8K MID/REAR JACK REPLACEMENT, ORIGINAL (8 HOLES) VS. CURRENT (7 HOLES)

QR-146

LEVELING AND STABILIZATION

Fig. 1

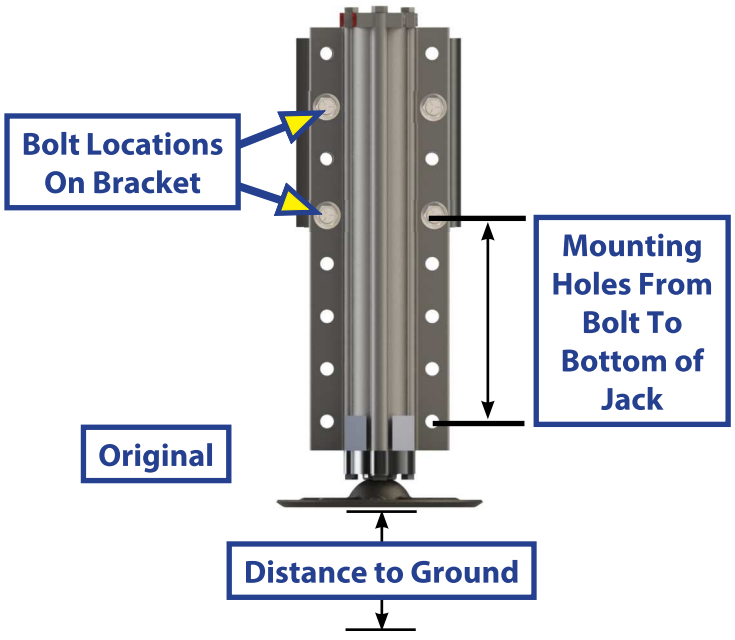
This document compares the differences between the original eight-hole 8K jacks and the current seven-hole 8K jacks and lists procedures to ensure proper installation of the current jacks. The current jack is also an inch shorter in height.

1. Before removing the original jack, note the location of the mounting holes on the jack and the mounting bracket (Fig. 1).

NOTE: Count the number of mounting holes from the first bolt to the bottom of the jack.

2. Measure the distance from the ground to the footpad of the retracted jack (Fig. 1).
3. Remove original jack.
4. To install current jack, match the number of mounting holes from the first bolt to the bottom of the jack (Fig. 2).
5. Put current jack in place and install bolts in the same location based on the number of mounting holes to the bottom of jack.
6. Measure distance from footpad to the ground to verify installation is correct (Fig. 2).
